City of Piedmont
CITY COUNCIL AGENDA REPORT

SUBJECT: Receipt of a Presentation from Richard Young of Aquatic Commercial Consulting Regarding a Current Condition Assessment of the Piedmont Community Pool

City of Piedmont Community Swimming Pool Facility Pool Evaluation

September 2018

PP-1 Deck cracks, staining

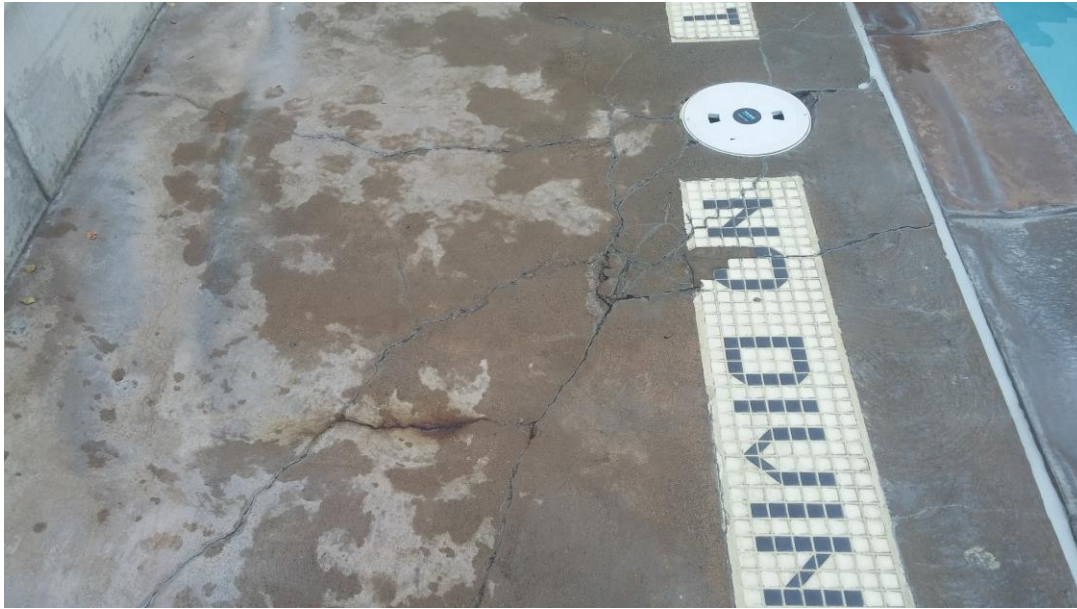
- A. There are number of deck areas with unsightly stains or failed concrete surfaces, cracks and uneven sections. These are especially evident around the Medium Pool deck area (see Medium Pool vessel section). These present a trip hazard and are lacking compliance with CHSC, MAHC and IS. PP-1, 2, 3, 4

1. Grind down any areas that present a trip hazard. (2-3 day pool closure)
2. Fill any cracks that present a toe-stub hazard.

PP-11 Missing deck depth markers on Wading Pool

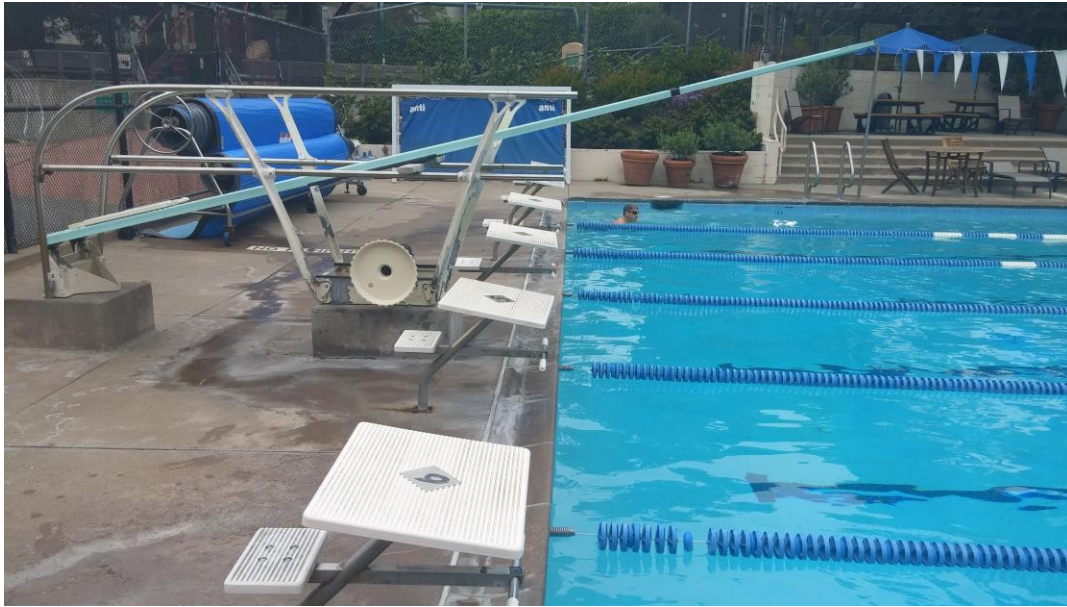
- F. There are no deck depth marker signs around the Wading Pool per CHSC which presents a risk hazard. PP-11 NOTE: See also Pool Vessel section.

Install new depth marker signage, two at each end and one on either side of the pool per CHSC. These may be “stick-on” signs.

PP-12 Starting platforms

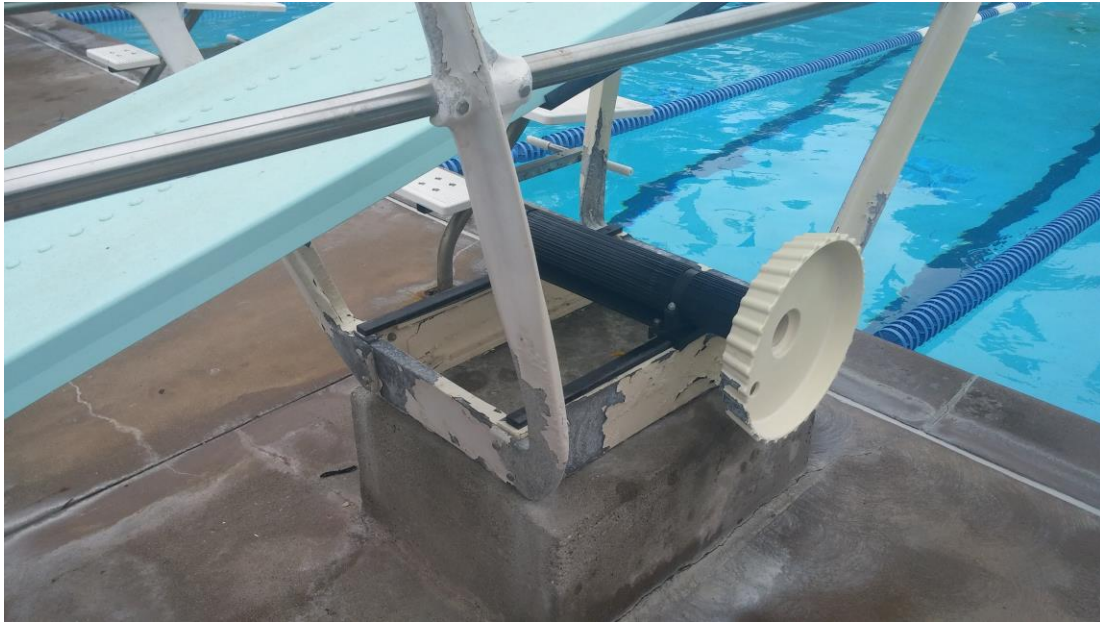
- A. The starting platforms are more than 15 years old and appear to have been installed poorly and are not in line (plumb) with the pool edge. Several of the anchors are corroding and staining the concrete around anchors. The steps and platforms are showing signs of deterioration.

It appears that the starting platform posts have been fastened to the deck anchors with something other than stainless steel hardware. In addition, CHSC and the MAHC call for the platforms to be covered or removed when not in use. PP-12, 13

1. Install proper starting platform safety covers or remove them after each swim team practice. Starting platforms may only be in place and used by swim team members when a coach is present. Covers are available through distribution. CHSC, MAHC

2. Install new state of the art starting platforms.

3. Remove the platform posts and reinstall them with stainless steel hardware.

PP-17 Diving board slip resistant coating failing

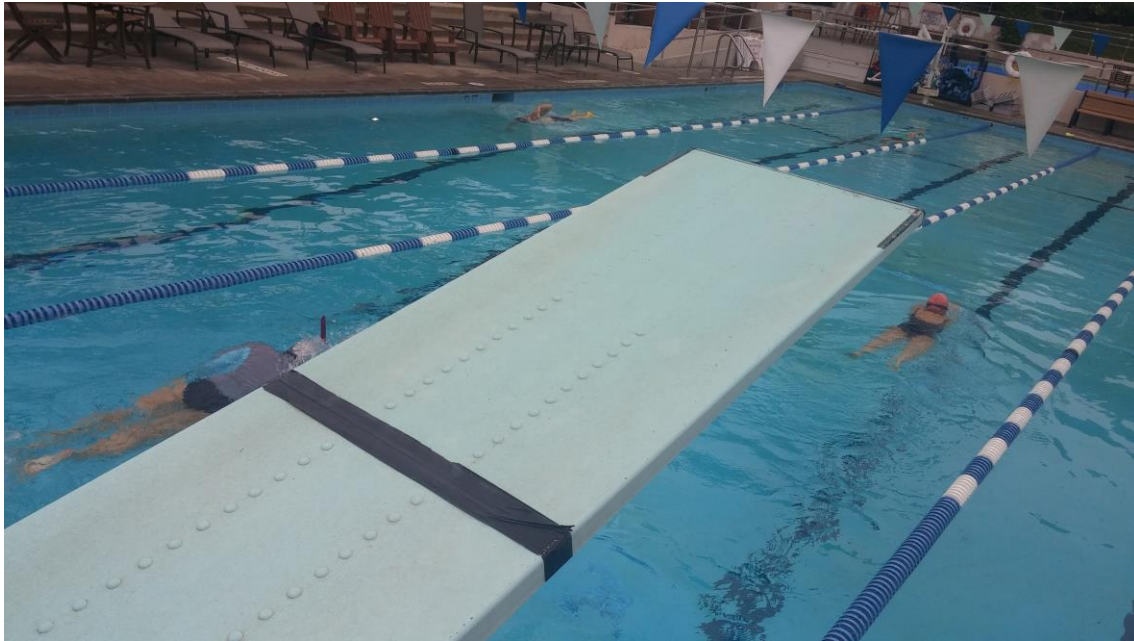
- B. The diving board does not comply with current CHSC or sanctioning diving agencies, as the depth of the pool is too shallow for a full 1-meter platform and board. A minimum of 11.5 feet of water depth is required. The diving board adjustable fulcrum should always be in the forward and locked position unless a diving coach or instructor is present. The diving stand coating has deteriorated considerably and the aluminum structure is exposed to the elements and is corroding. The diving board surface is worn and presents a slip hazard. PP-15, 16, 17

1. Remove the 1-meter stand and install a $\frac{3}{4}$ meter stand with a recreational diving board. This will require County Health Department approval.

2. Remove the dive standard, have it sand blasted and recoated with epoxy paint. Remove the concrete pedestals and install the platforms flush on the deck to create a near $\frac{3}{4}$ meter unit. This too will require County approval.

3. Close the diving board for use. Remove the platform and the concrete pedestals from the deck

PP-24 Exposed pool covers

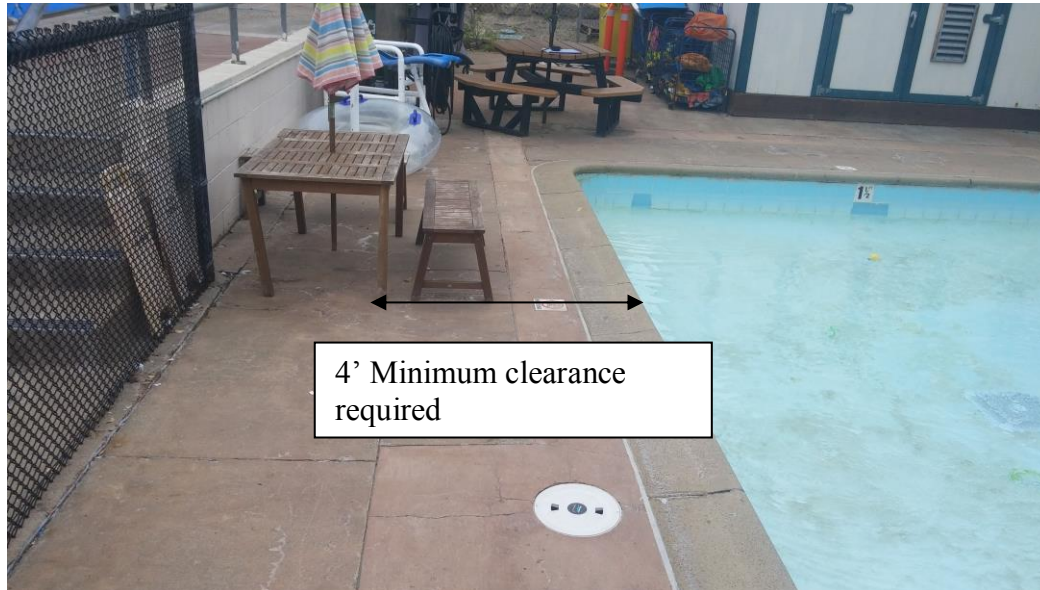
- H. The pool covers are damaged by exposure to the direct ultra violet light from the sun. After being rolled up the same section is exposed every day. The addition of simple, inexpensive covers will extend the life of the covers measurably. The same is true for the lane line reels not pictured. PP-24

Purchase covers for pool cover reels.

PP-34 Uneven deck sections around Medium Pool

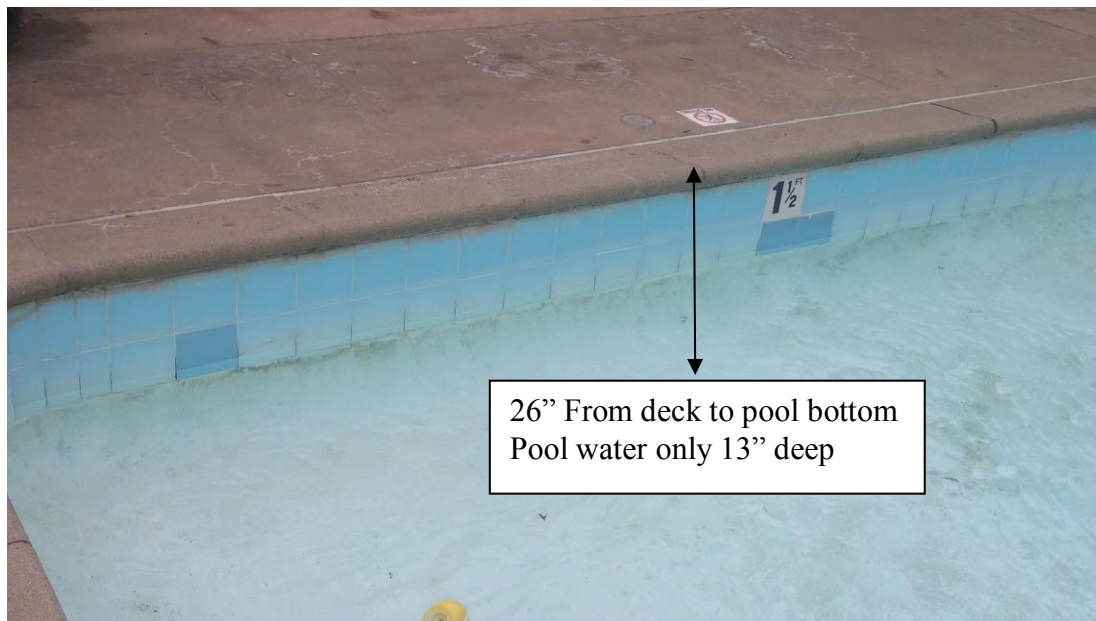
- D. Staff reports Medium Pool continually loses water. The automatic fill system compensates for the water loss. But the line is not equipped with a water meter to determine the amount of replacement water used on a daily basis. It is evident there are soil issues occurring as the deck has dropped and has left the pool edge/deck interface uneven which presents a trip hazard. This circulation system could not be pressure tested at it makes use of the surge tank with gravity flow lines. Destructive testing would be required to determine if the leak is in the collection or return lines. The adjacent concrete sections near the deep side of the training pool have been dislodged. PP-34

Complete the destructive testing required to pressure test and conduct leak detection. This may require replacement of the deck area on the deep side of the pool. Make repairs. NOTE: The location of this leak is unknown.

PP-35 Step off from pool deck into 13" of water – Wading Pool

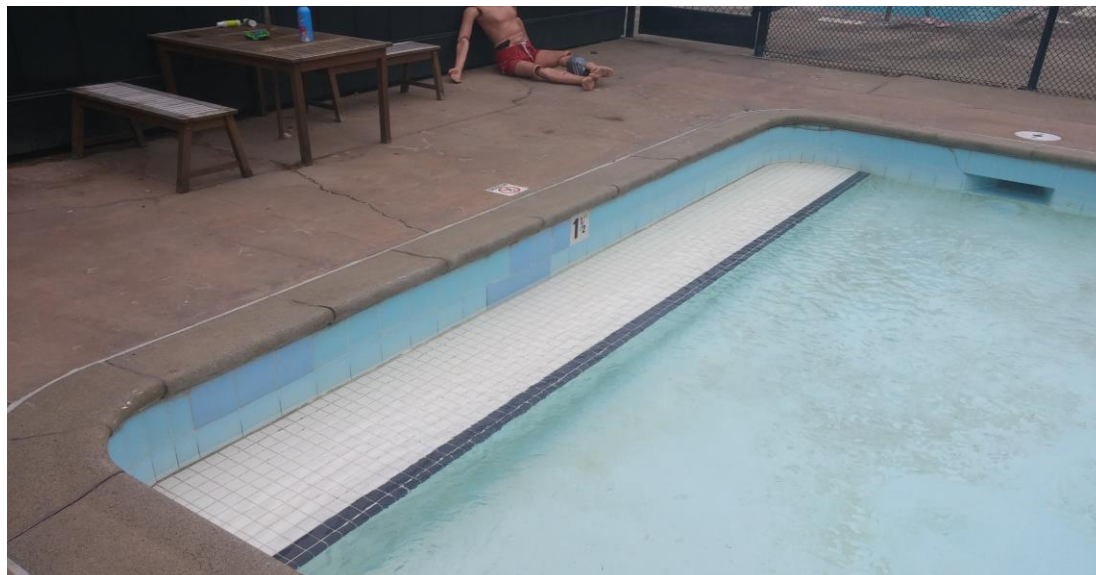
- A. The Wading Pool is 26" from the deck to the pool bottom and the water is only 13" deep. The depth markers indicate 1.5' (18") so the actual drop is 26" if someone were to step off the pool edge. With the water level being only 13" as opposed to 18" as labeled on the tile depth markers, the result could cause serious injury. PP-35, 36

1. Add deck signage that calls for entry to the pool at the steps only. (See also deck issues for handrails).
2. Raise the water level as far as possible to bring the depth as close to the 1.5' and still have the skimmers operate.

Reconfigure the pool depth by changing the pool bottom configuration to comply with CHSC for a total of 1.5 feet depth and a 6" deck to water level dimension.

Pump Curve of existing unit. (Target for flow and pressure off 10 HP curve)

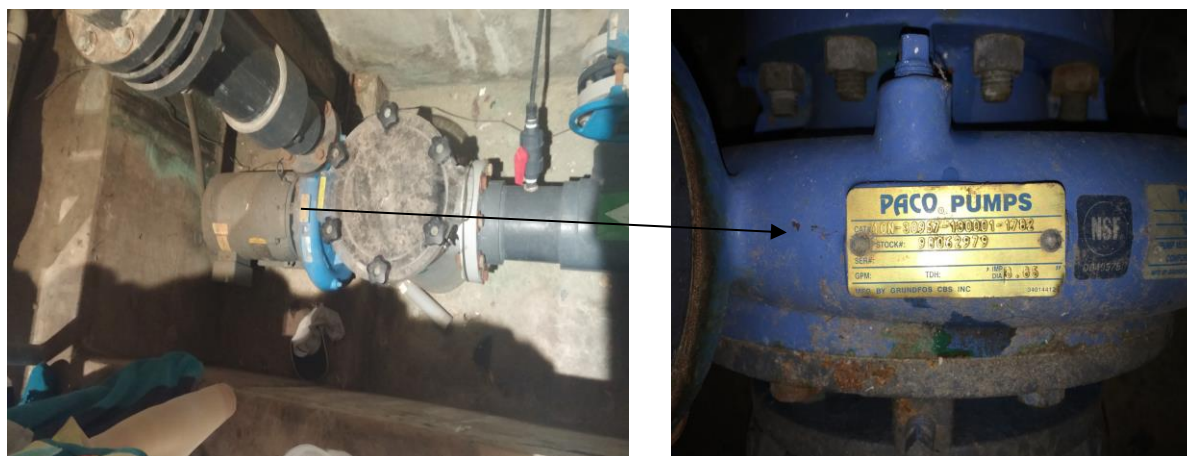
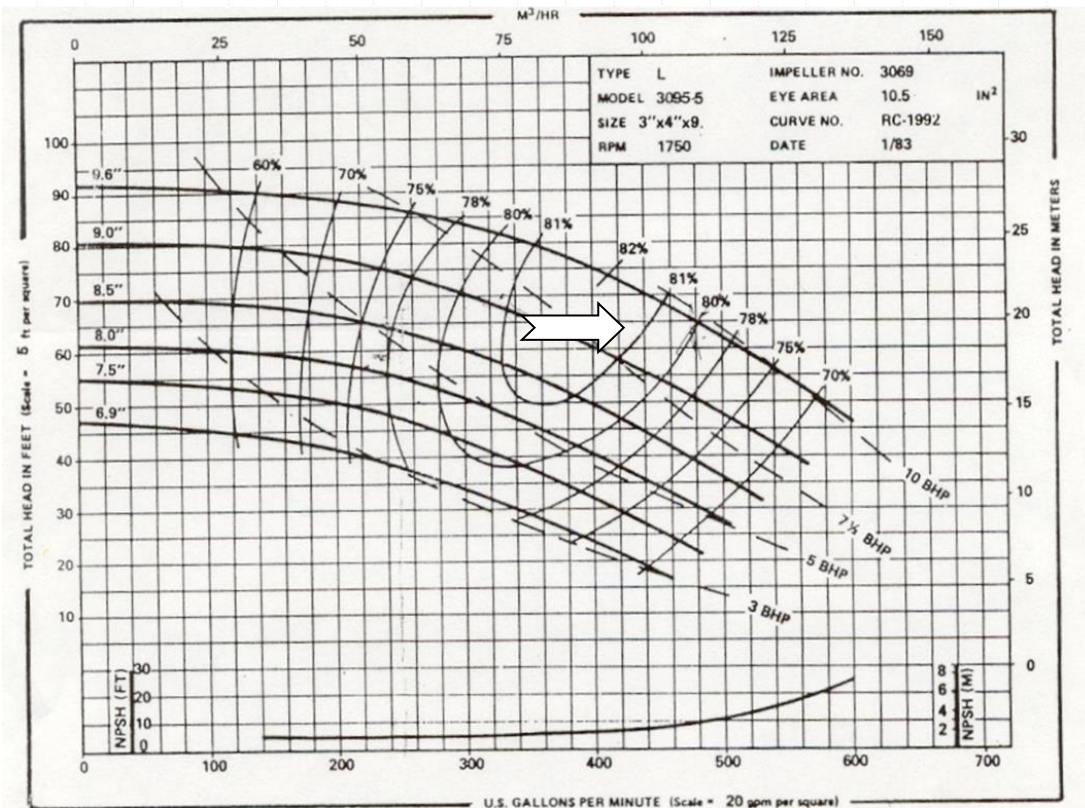
A. The main recirculation pump is 10 HP. This pump makes use of only a standard efficiency motor. This particular pump model PACO-3095-7 is operating at a greater than desired flow rate resulting in the pump drawing more HP and amperage than its design in an effort to achieve the 430 GPM flow rate required. This was an identical replacement of the original pump that was designed for an 8-hour turnover at a flow rate of only 320 GPM. The current code has called for a 6-hour turnover requiring 430 GPM for more than 10 years. This pump operates at an elevated temperature but continues to achieve the desired and code required flow rate. At present the flow rate falls just below 400 GPM. The pipe size (6" @ 800 GPM) and filter capacity (42 square feet @ 15 GPM/Sq. Ft 630 GPM) far exceed the pump's maximum output. PP-38, 39

The new model pump would benefit from a Variable Frequency Drive (VFD) control, as the output, even with 10 HP, is higher than needed. A VFD would allow for the

1. Install a new PACO 4095-7 (keep 10 HP motor)

2. Install a programmable VFD

PP-41 Chemical monitoring and control systems

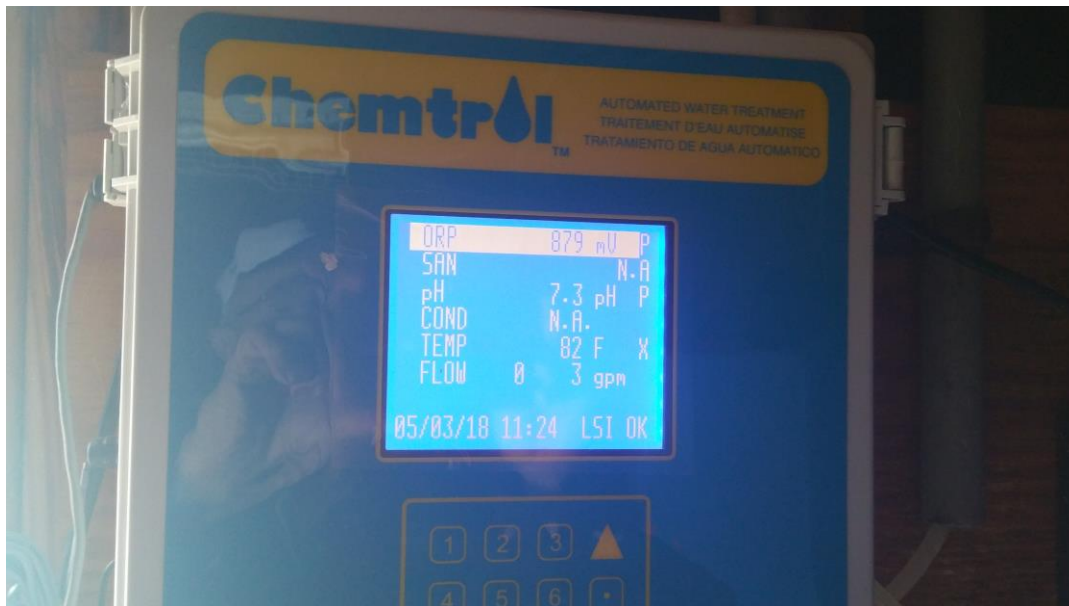
- A. All the pools are fitted with automatic chemical and monitoring systems with the Main and Medium Pools having the latest models. These units are capable of internal

recording the water chemistry parameters, but do not comply with current Title 22, code for the capability of down loading this information. The Wading Pool makes use of an older vintage control that does not have record keeping or telemetry capabilities. All the units monitor chlorine and pH levels and are fitted with an integral flow switch. PP- 41, 42

1. Install telemetry devices for the downloading of the water chemistry parameters record for the Main and Medium Pools.
2. Install a new controller on the Wading Pool capable of recording chemical parameters and also telemetry for the down loading of records.

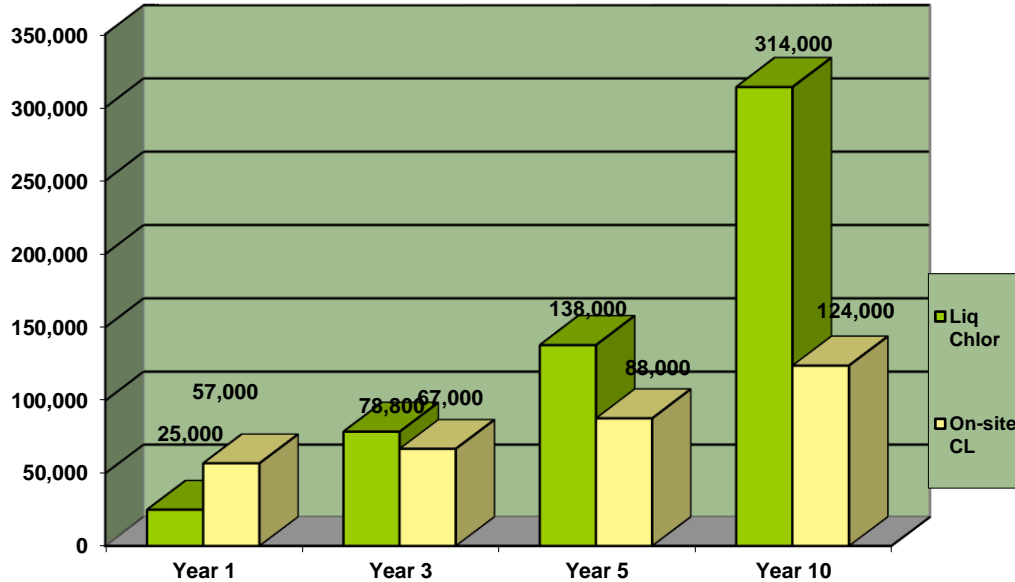
- E. The disinfection systems make use of purchased 12% sodium hypochlorite (liquid chlorine). This chemical is expensive (approximately 2.10 per gallon) and has the highest pH influence of all the chlorine sources, requiring 1 gallon of acid for every 4.5 gallons of liquid chlorine fed. The delivered cost of chlorine to the pool is approximately \$2.60 per gallon. Sodium hypochlorite is a salt-based chlorine, which continually adds approximately 2.2 pounds of salt for every gallon of liquid chlorine added to the pool. Needless to say as a result, the salt and total dissolved solid concentration increases quickly.

The type of chlorine being used requires many barrels of the hazardous liquid chlorine and acid to be purchased, stored (at present in violation of UFC-Art. 80 and OSHA), and then handled by operating personnel to move the 15 gallon barrels to the various pool mechanical rooms for feeding.

Further investigate installation of inline, chlorine generation systems.
